**BELL BEND NUCLEAR POWER PLANT  
RESPONSE TO ENVIRONMENTAL  
REQUESTS FOR ADDITIONAL  
INFORMATION, SIXTH SUBMITTAL  
BNP-2009-313      Docket No. 52-039**

Responses to Environmental Requests for Additional Information  
Bell Bend Nuclear Power Plant  
Luzerne County Pennsylvania

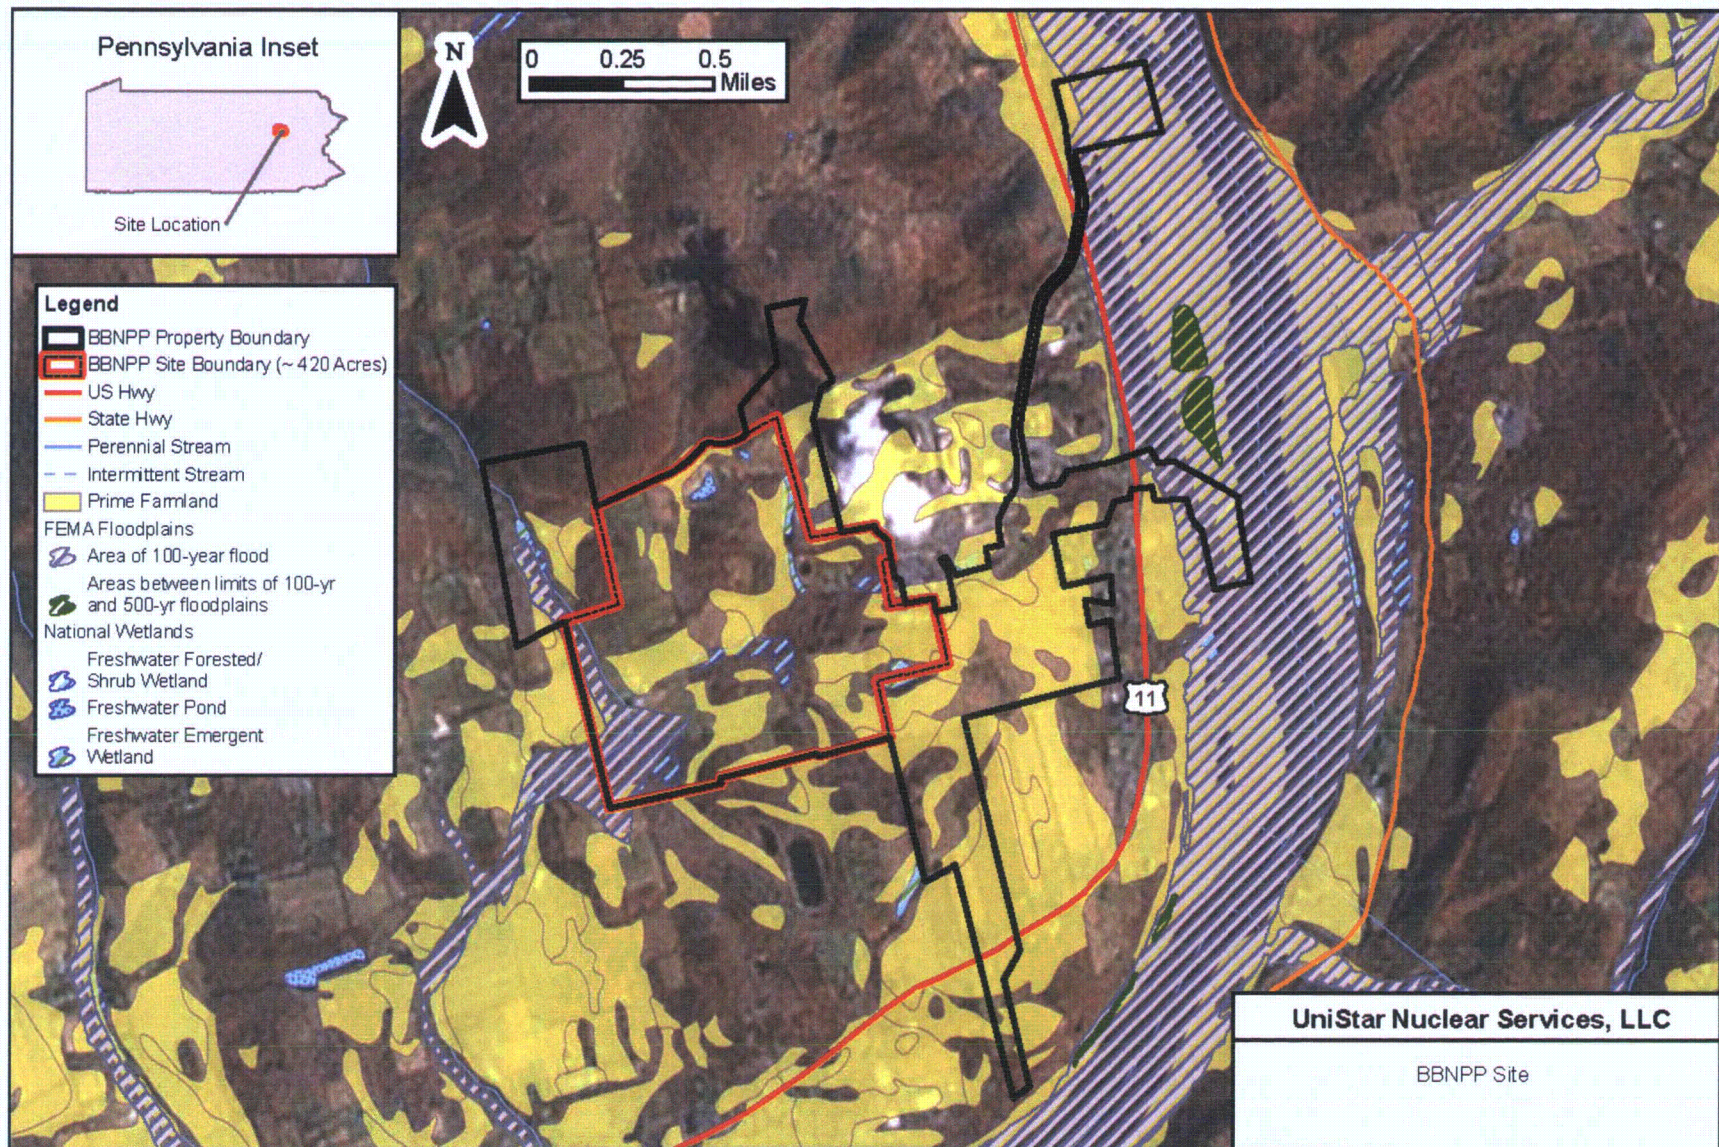
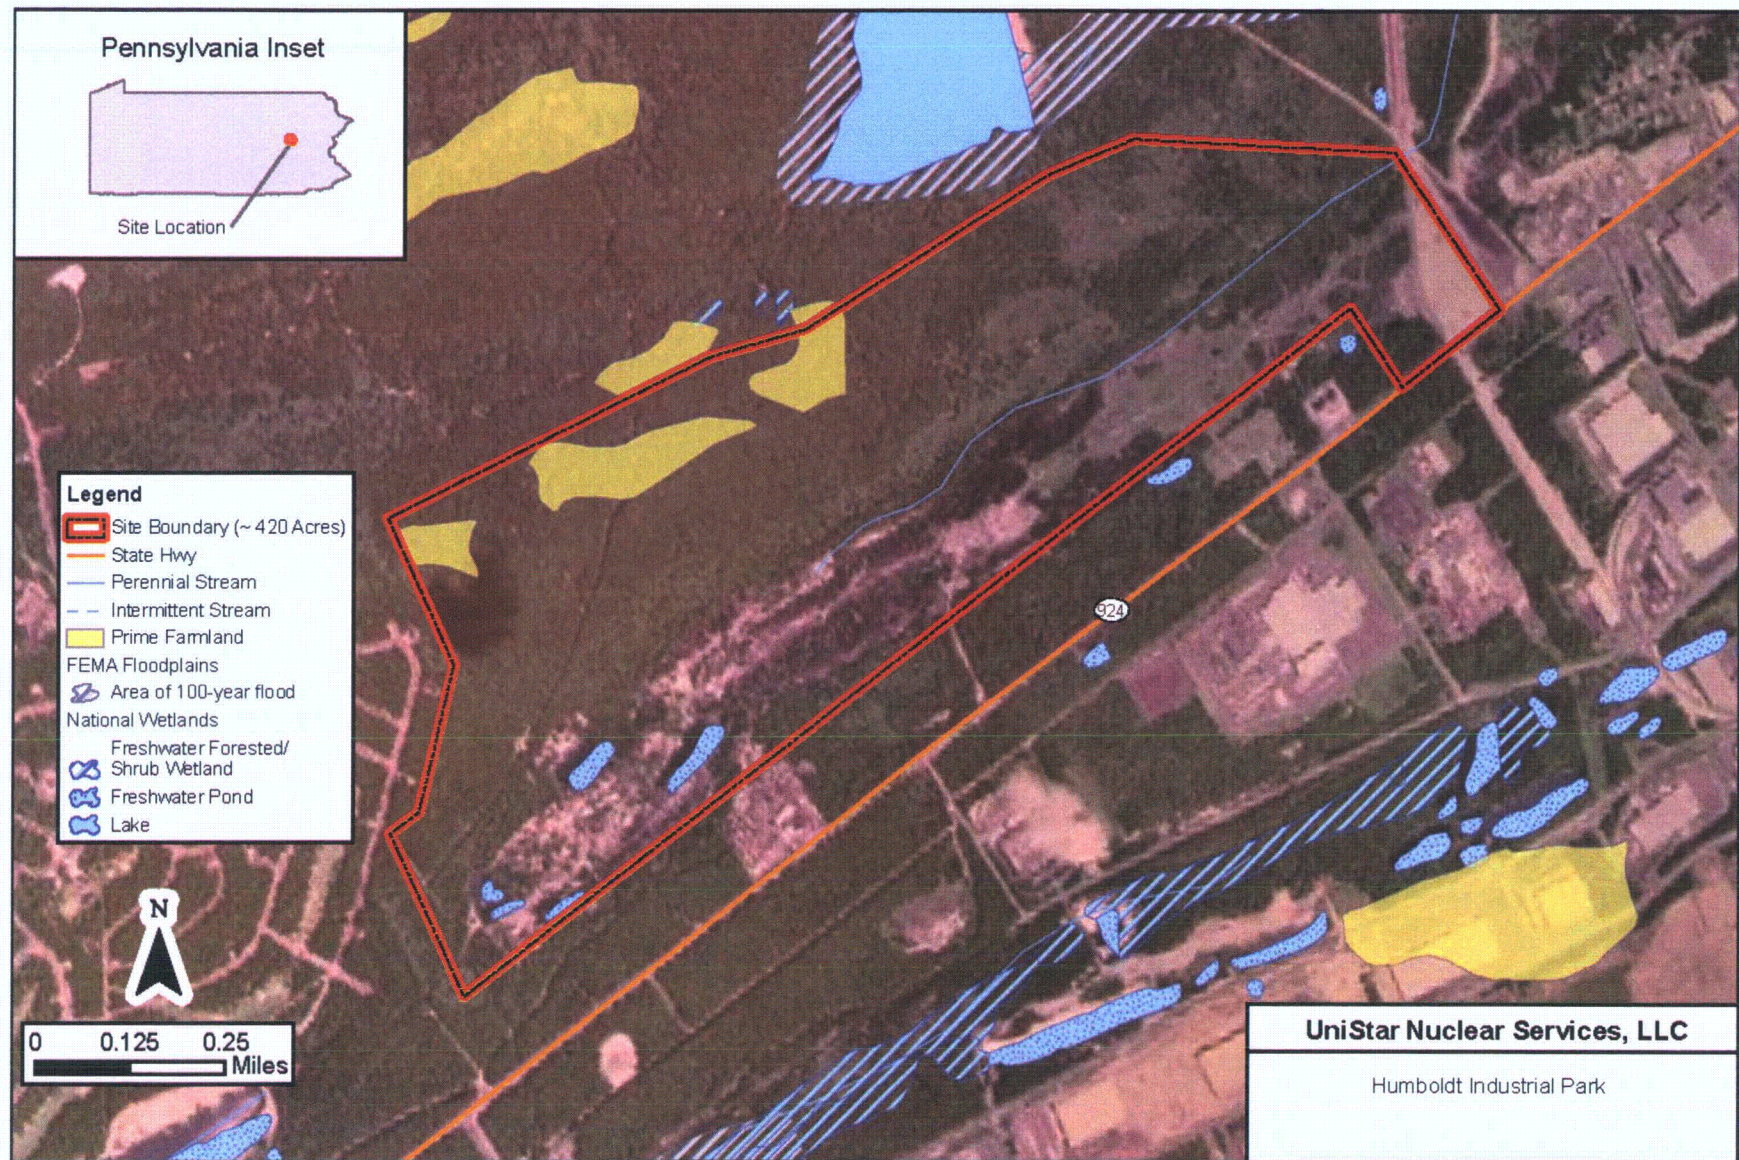
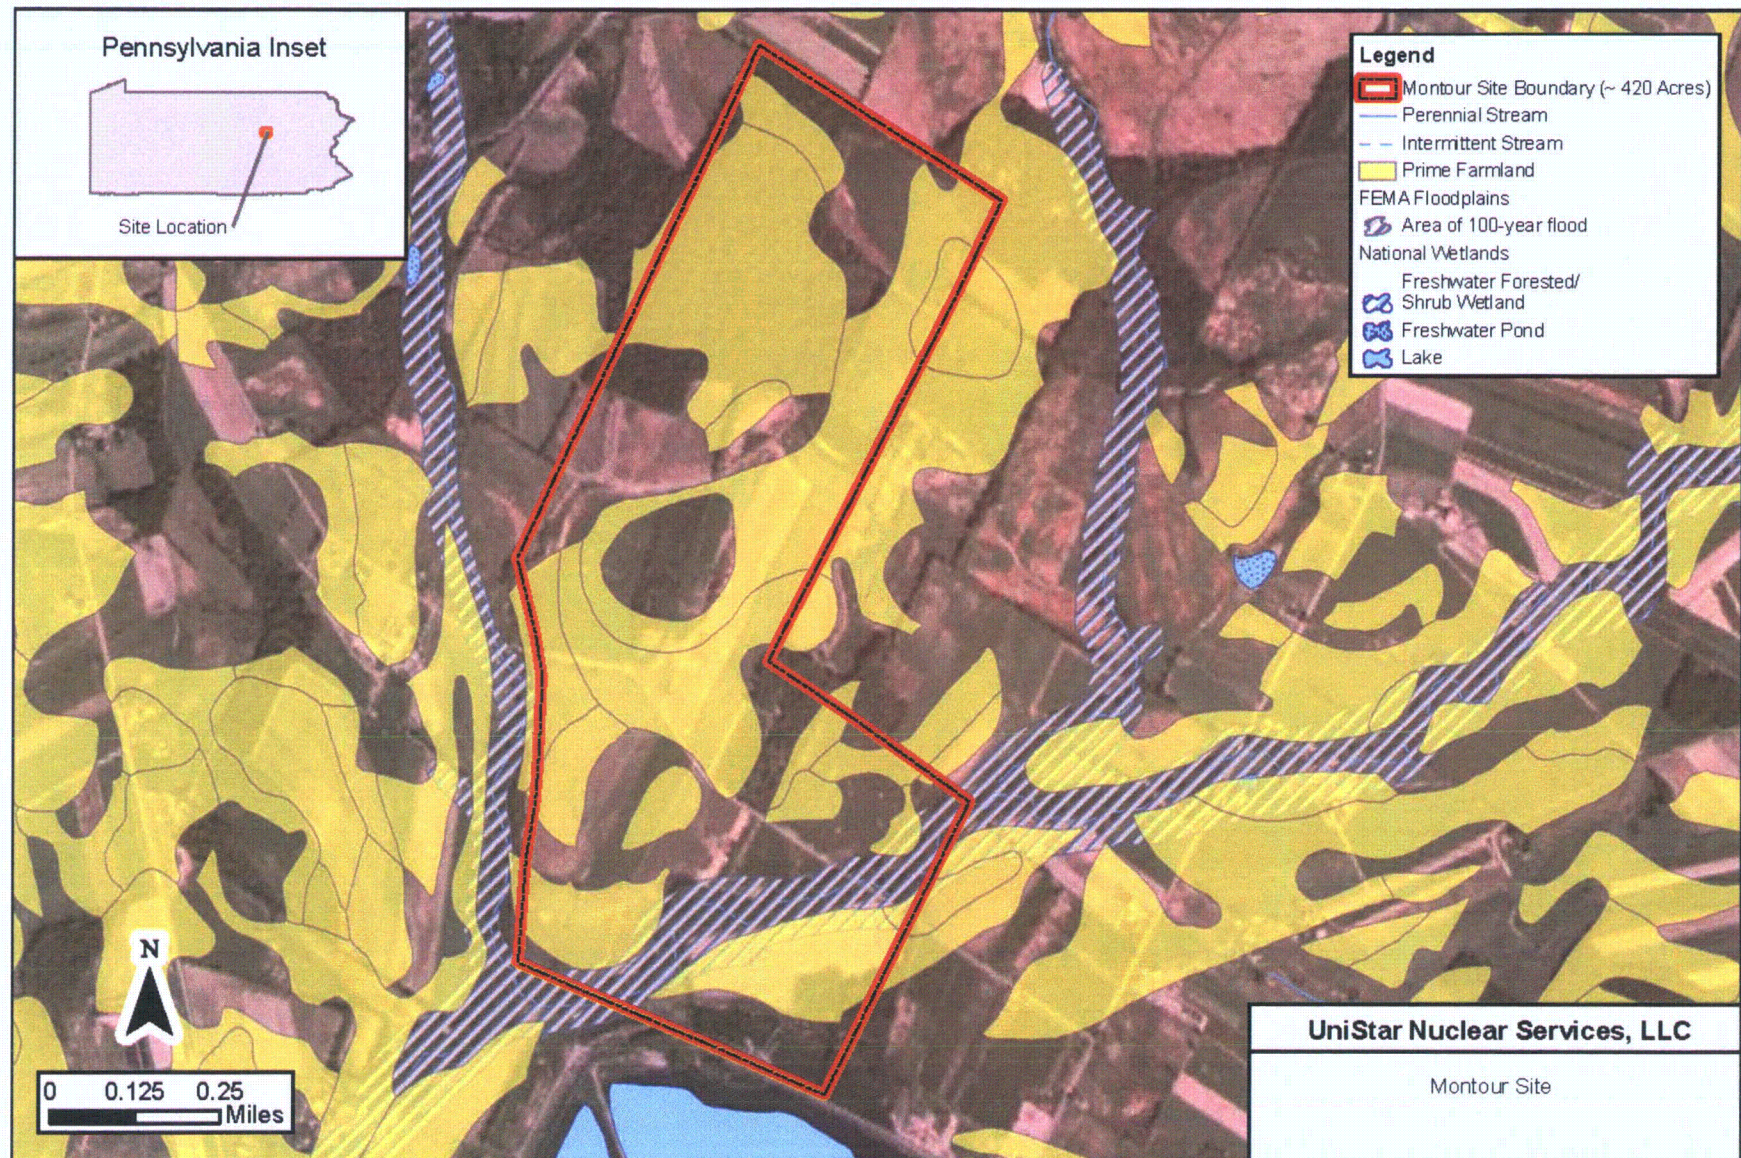
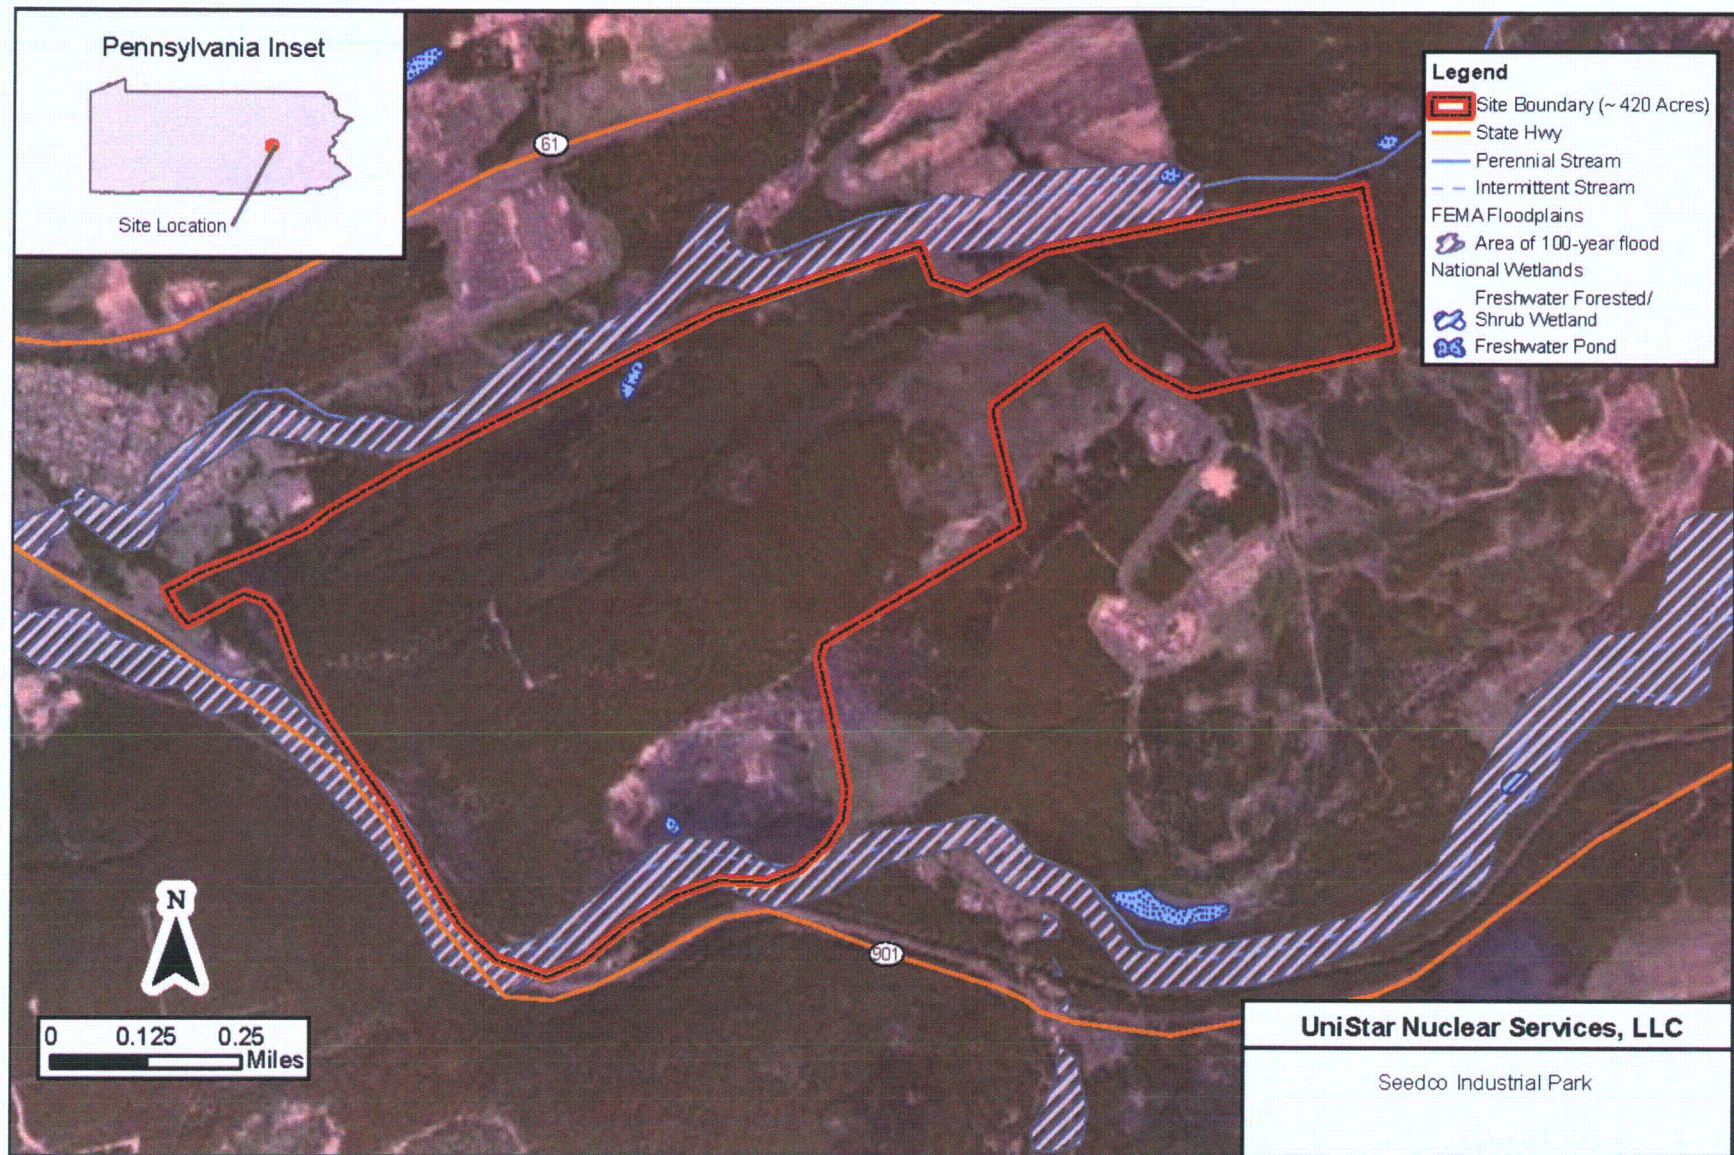
**Summary:** *Provide the detailed maps of the proposed site and all alternative sites that show floodplains (100 & 500 year), wetlands, and prime or unique farmland.*

**Response:** Detailed maps of the proposed site, Bell Bend, and three alternative sites (Humboldt, Montour, and Seedco) follow. Please note the following in reference to these maps:

- There is no designated prime farmland within the Seedco site or surrounding area shown in the figure.
- There are no mapped National Wetlands Inventory wetlands within the Montour site.
- The 500-year floodplain has no additional areal extent beyond the 100-year floodplain for Montour, Humboldt and Seedco (i.e., 100-year and 500-year floodplain for those 3 sites are the same). For BBNPP, there are a couple of small areas that are impacted by the 500-year floodplain beyond the extent of the 100-year floodplain. Therefore, that figure shows a legend symbol for the additional area between 100-yr and 500-yr floodplain but the symbol does not represent the extent of the 500-yr floodplain--just the additional area between the two floodplains.

### Figure 2.3-3 Walker Run Watershed

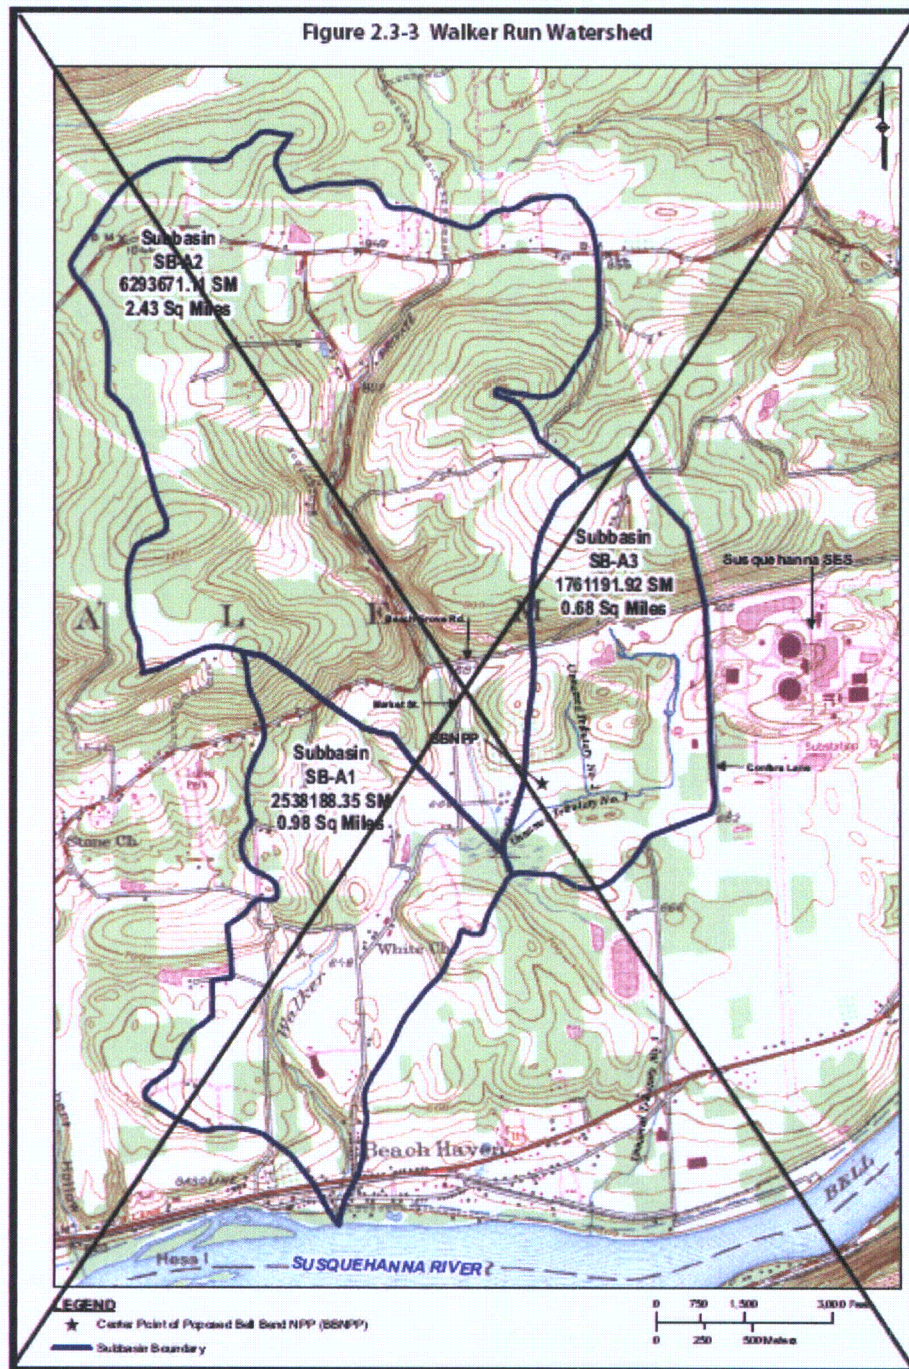
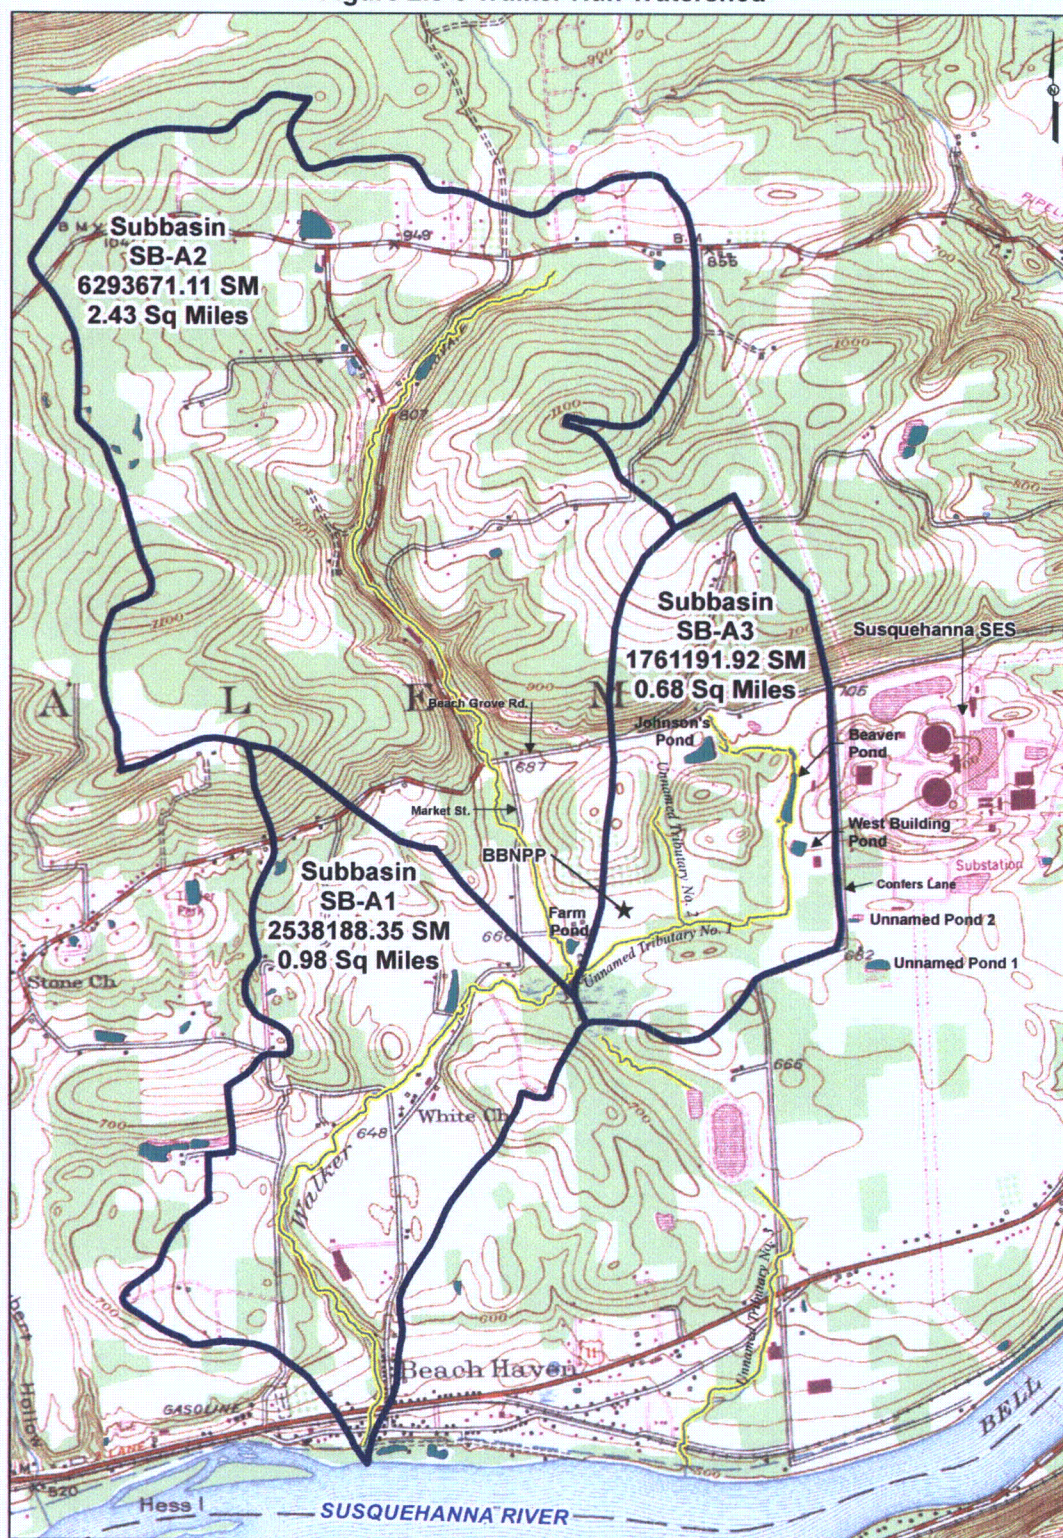
**Summary:** *Provide physical descriptions of and clarify differences between the hydrology and aquatic ecology sections for*

- *Unnamed Tributaries 1, 2, and 3; their correct locations, flow frequency (perennial, intermittent), flow paths, and drainage areas*
- *East Fork of Walker Run; its location, drainage area, relationship to mainstem Walker Run or other resources on or near the site*
- *all onsite ponds; the numbers, names, locations, and hydrological descriptions*

- Revised ER Figure 2.3-3 (in the COLA Impact section) shows locations of the perennial streams and ponds in the vicinity of the BBNPP. Note that the revised ER Figure 2.3-3 includes a specific legend entry for "Perennial Streams" and a legend entry for "Lake/Pond". ER Figure 2.3-3 also identifies the drainage area for each of the subbasins in the Walker Run watershed. These subbasins and the drainage areas are as follows: Subbasin SB-A1 (0.98 mi<sup>2</sup>), Subbasin SB-A2 (2.43 mi<sup>2</sup>), and Subbasin SB-A3 (0.68 mi<sup>2</sup>). Unnamed Tributary Nos. 1 and 2 are part of Subbasin SB-A3 as shown in revised Figure 2.3-3.

A second ~~unnamed~~ perennial tributary flows southeastward from the BBNPP site and empties into the Unnamed Tributary No. 1 (East Fork of Walker Run) (Figure 2.3-3). Its drainage area is part of the ~~Walker Run watershed~~ Unnamed Tributary No. 1.
